# FACPAC Contract Change Order Supplemental Information Form (Ref# 60467)

Tier 1 Project: Phase 6 Additions and Renovations - Project #175-520

CHANGE ORDER NUMBER: 216-06  
 INITIATION DATE: 8/1/2024

Additional cost to add floor boxes in Video Room 129. \$14,831  
 Additional cost to add theater lighting and LED logo. \$23,603  
 Additional cost of adding power and data in various locations. \$60,726

# PARTIAL MAIN LEVEL - PR-24

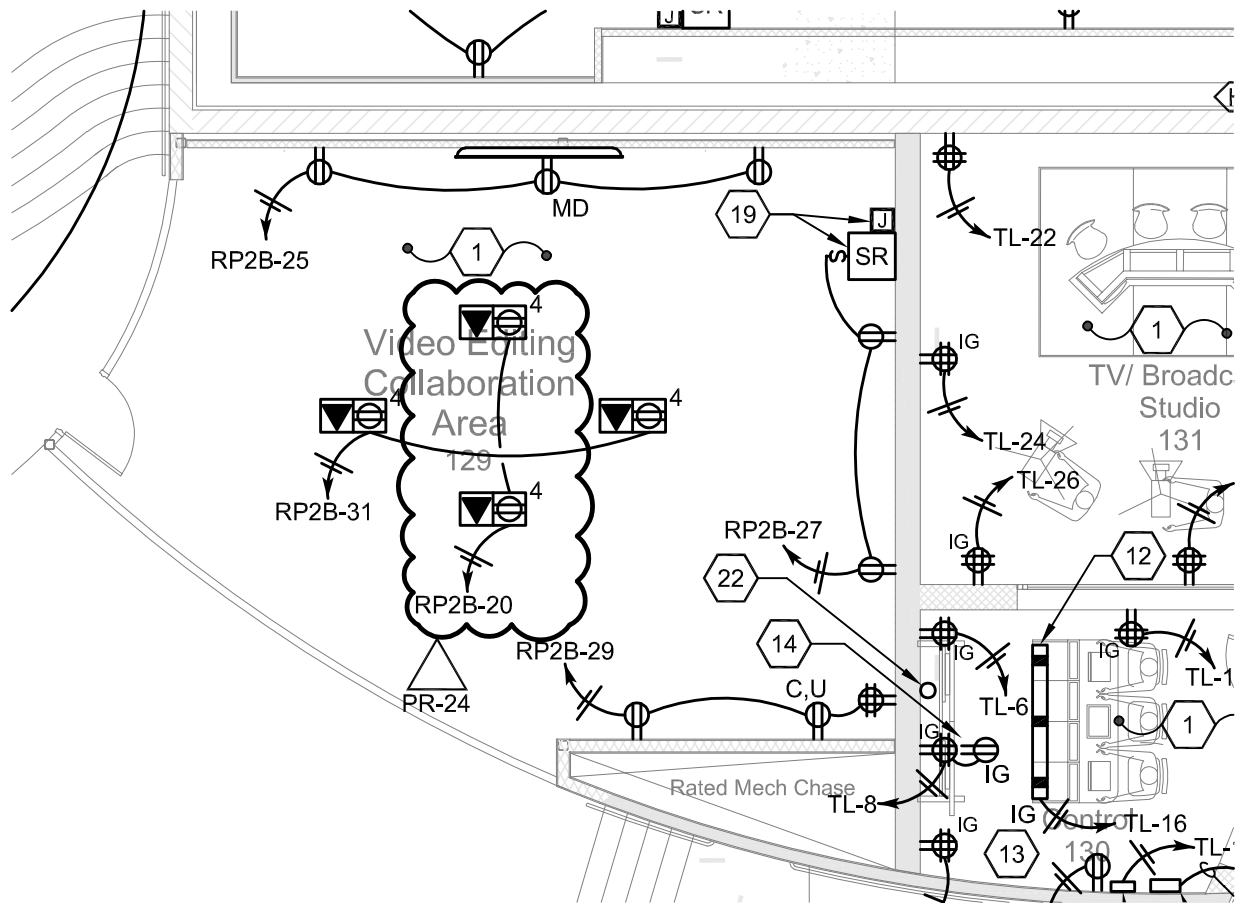
Additional floor boxes in Video Editing Collaboration Room 129 - see attached sketch SKE202c from STW.

**E102**

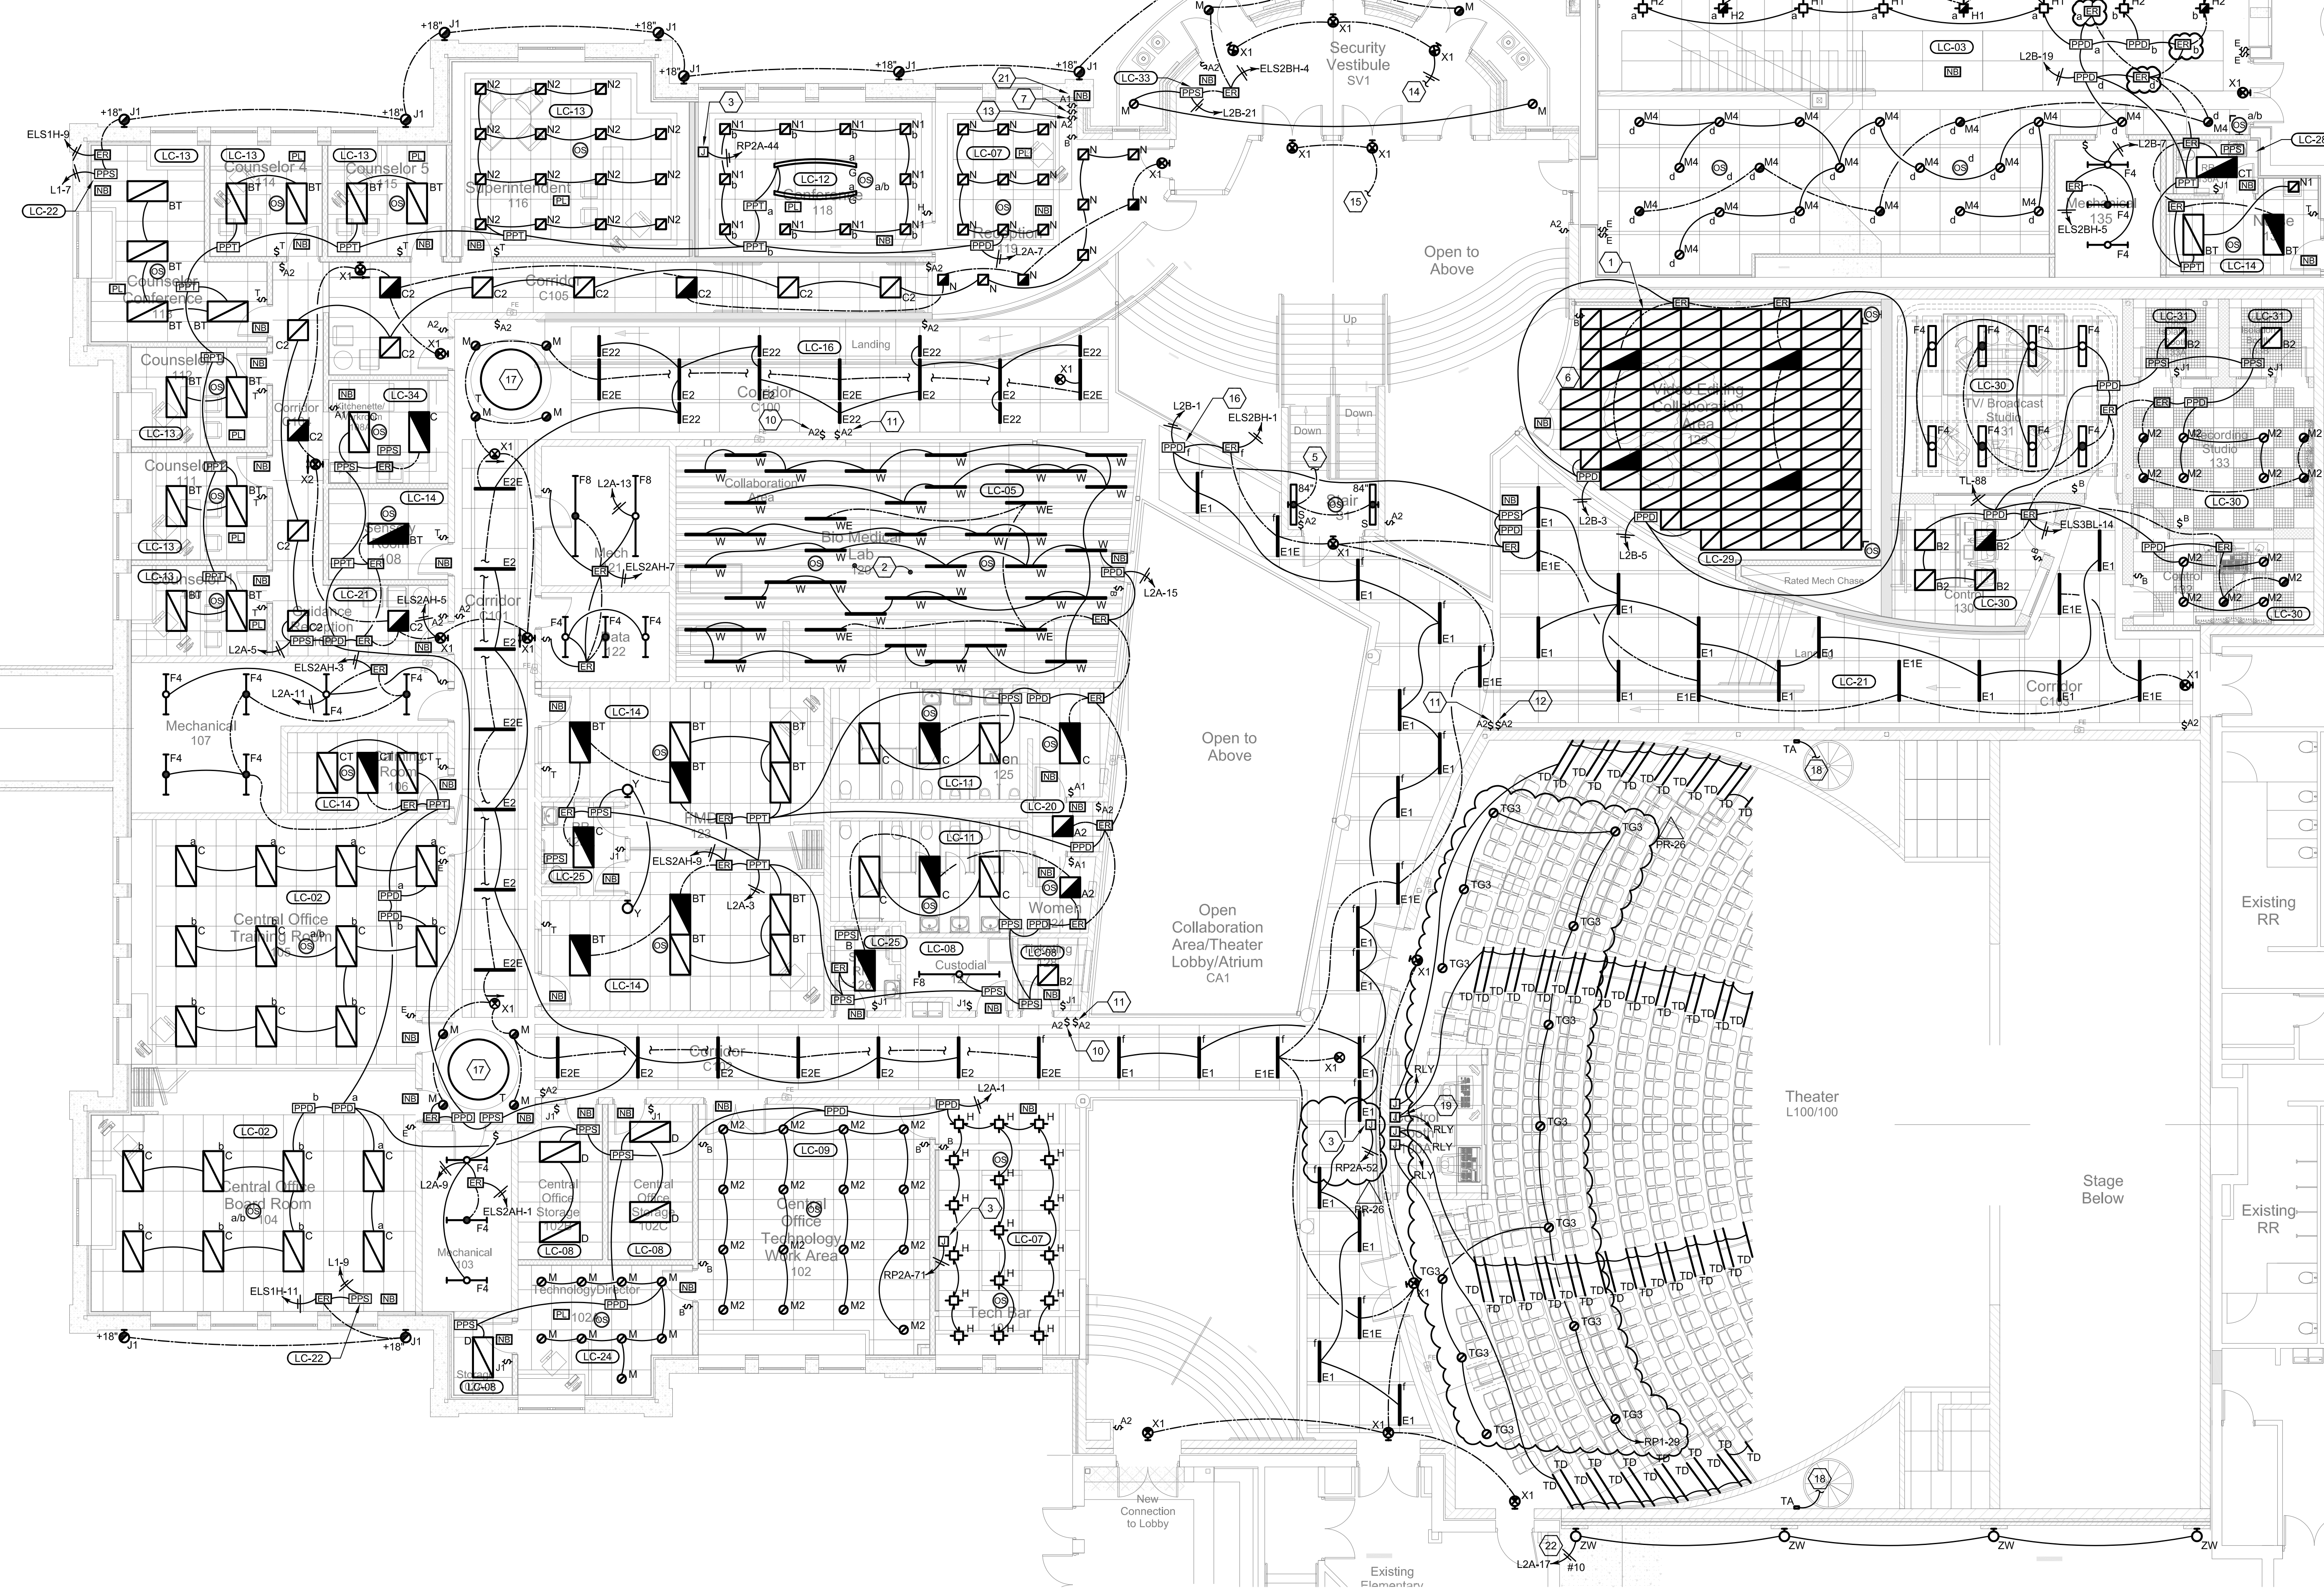
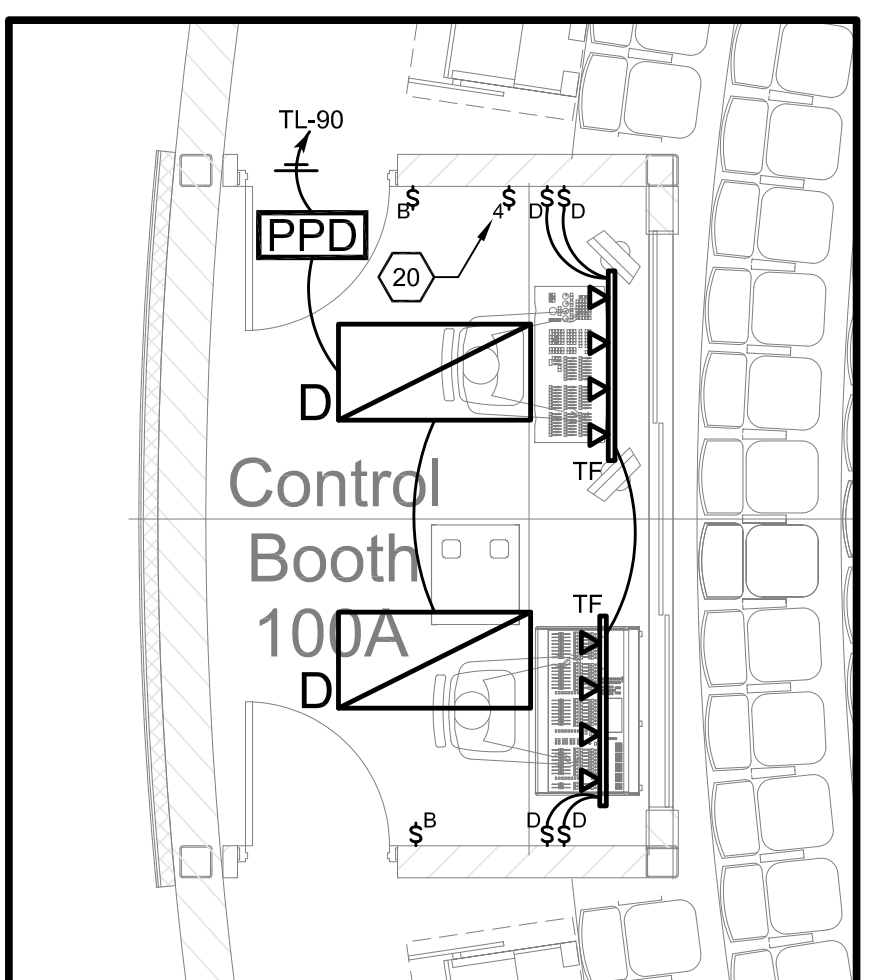
Please provide pricing for the addition of light fixtures as indicated on attached drawings E102. The new light fixture shall be manufactured by Gotham Lighting, model ICO-35/20-6AR-60D-120-EDXB or equivalent. The light fixture shall be DMX controlled and connected to the stage lighting relay panel (RP1) as indicated on the attached drawing. The light fixtures shall be installed underneath the theater balcony as indicated on the attached drawing.

Please provide pricing for the addition of a hardwired connection for Backlit LED logo as indicated on attached drawing E102. Provide power from spare circuit in panel RP2A as indicated on plan. Provide a dedicated lighting control network bridge and switching power pack for control. LED logo shall be time of day controlled. Field coordinate time of day scheduling with owner. Field coordinate exact junction box location with LED logo to provide a concealed connection.

Refer to attached Drawing E102 for design modifications.

- PROVIDE HARD WIRED CONNECTION FOR BACK LIT LED SIGN. PROVIDE DEDICATED LIGHTING CONTROL NETWORK BRIDGE AND SWITCHING POWER PACK FOR CONTROL. PROVIDE A DISCONNECT SWITCH ABOVE THE NEAREST CONCEALED ACCESSIBLE CEILING.

**E202**

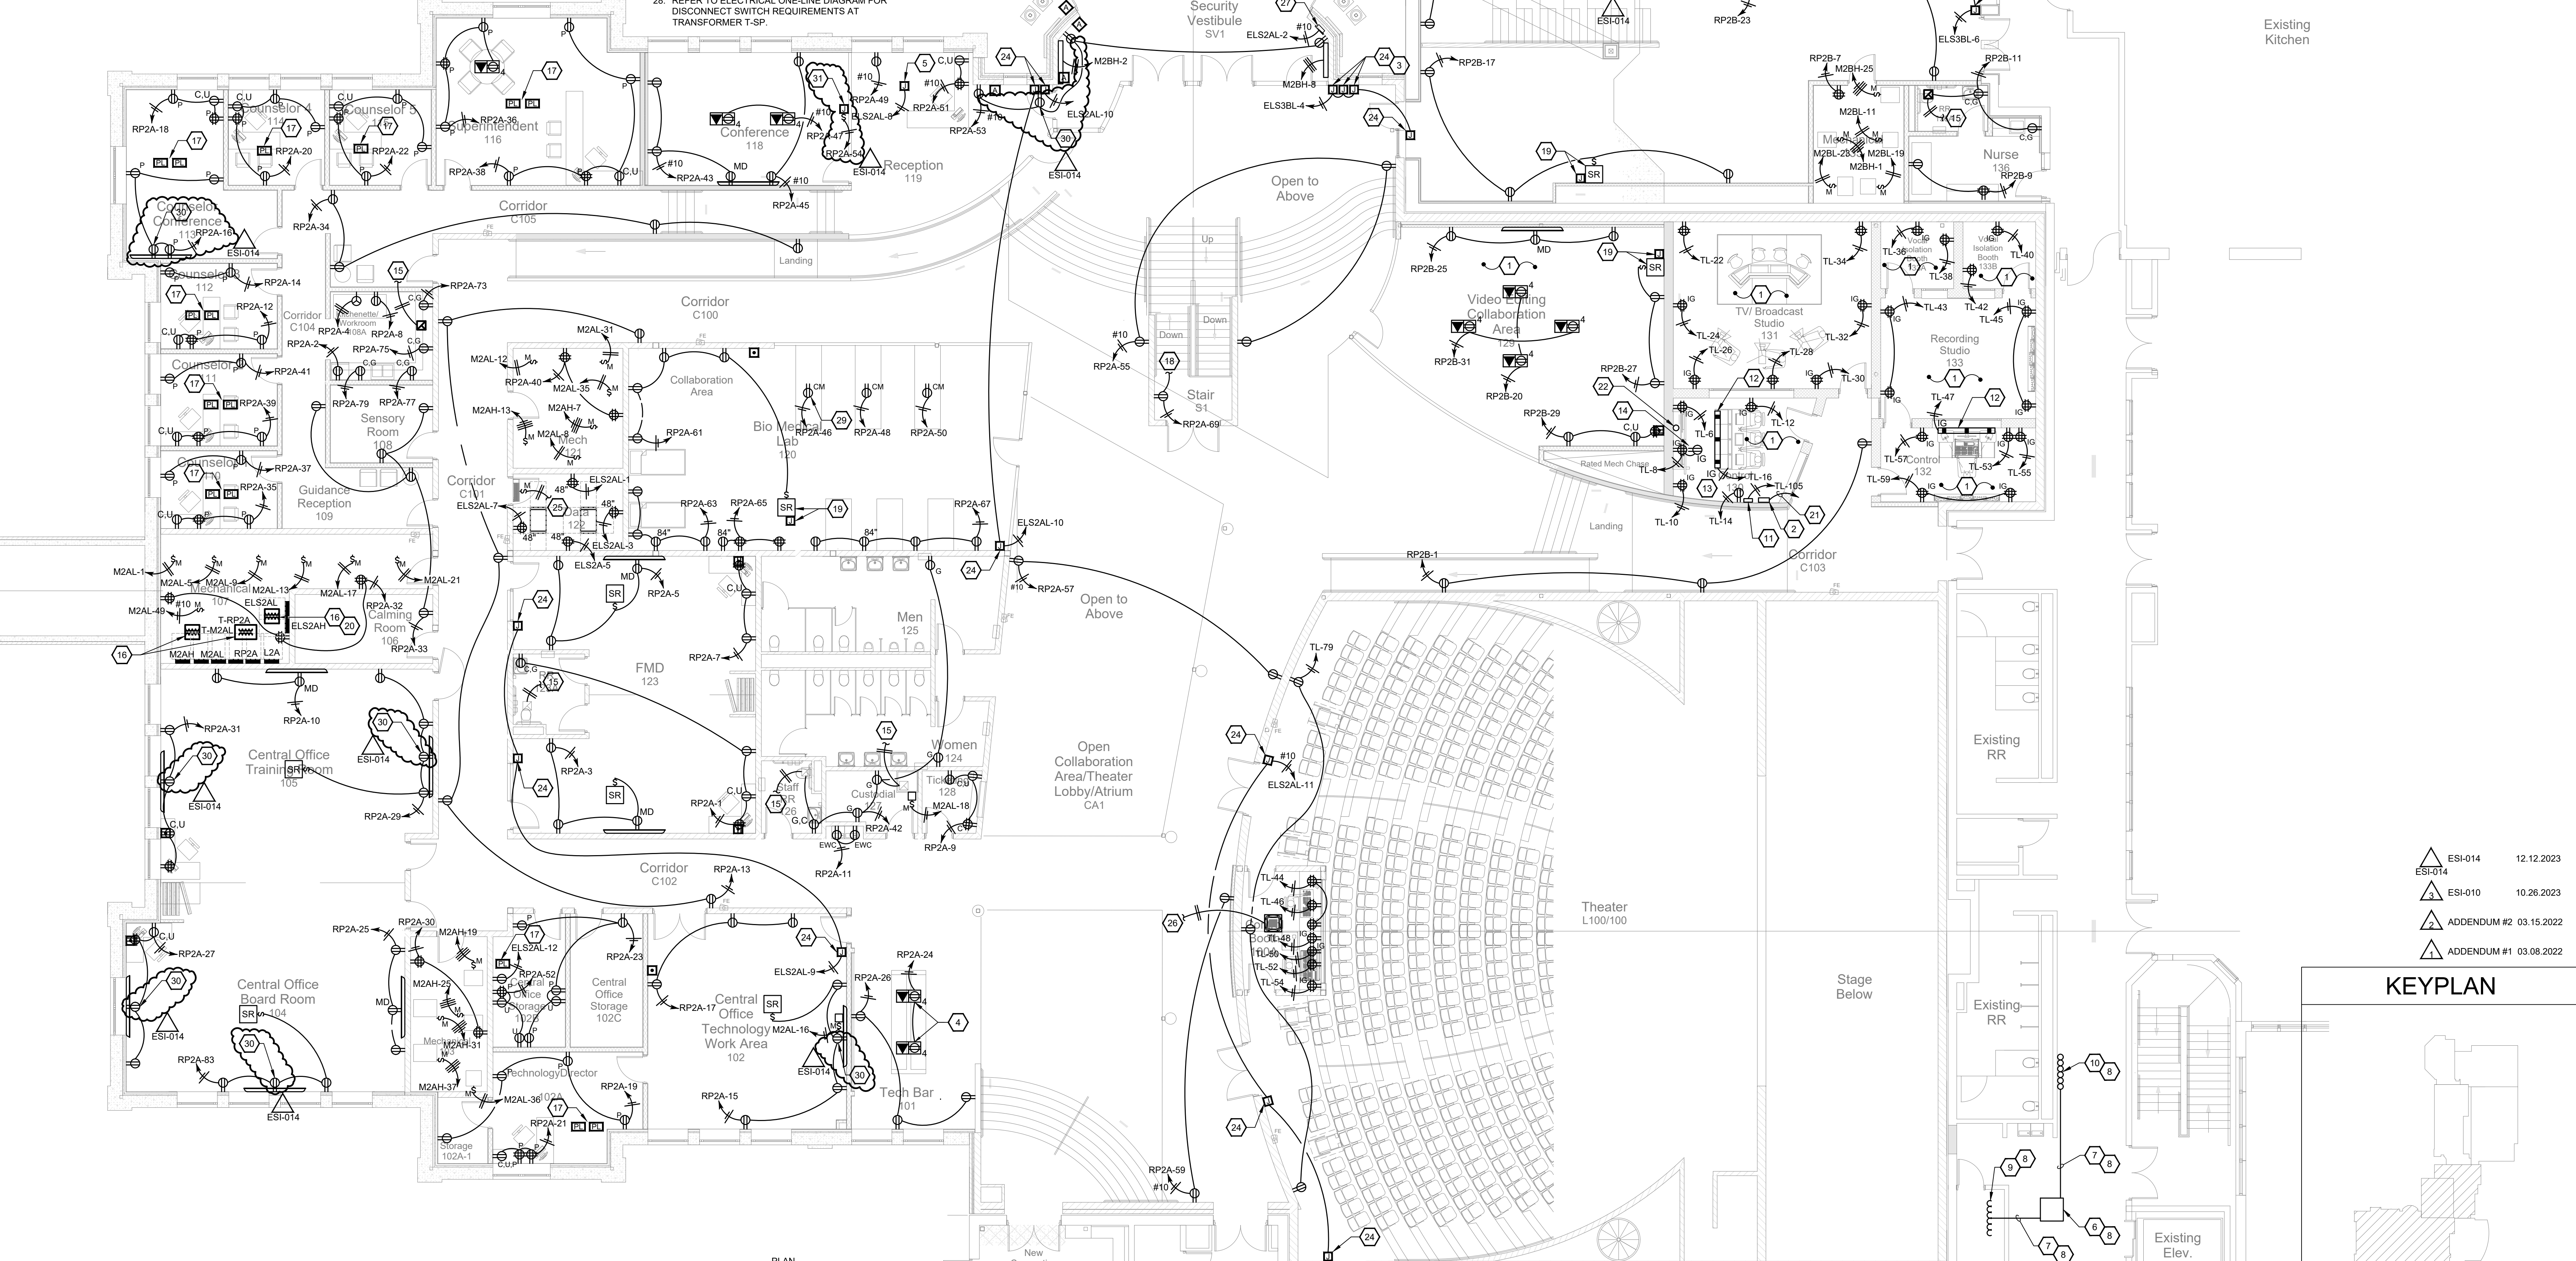
Electric changes in Media Center 134 (STW ESI #14)  
Reference sheet E202:  
Added power for TV's in rooms 102, 104, and 105.  
Added USB receptacles and circuits on Social Steps 134B.  
Reference sheet E204:  
Added power for TV in corridor C201.  
Added power and circuiting for horizontal ticker screens in rooms 206 and 208.  
Added power for vertical wall TV in room 208.  
Added power and circuiting for garage door in room 206.  
Added poke thru receptacles and circuiting in room 215.  
Reference sketch E204A:  
Added wiremold, power, and data for computer stations in room 208.  
Added Panel RP2C and 45 KVA Transformer T-RP2C in room 208 for computer station circuits.  
Reference Sheet E304:  
Added data drops directly adjacent to ticker receptacles.  
Reference sheet E501:  
Details referring to surface raceway added in room 208.  
Reference sheet E601:  
Panel RP2C and T-RP2C added to one-line diagram.
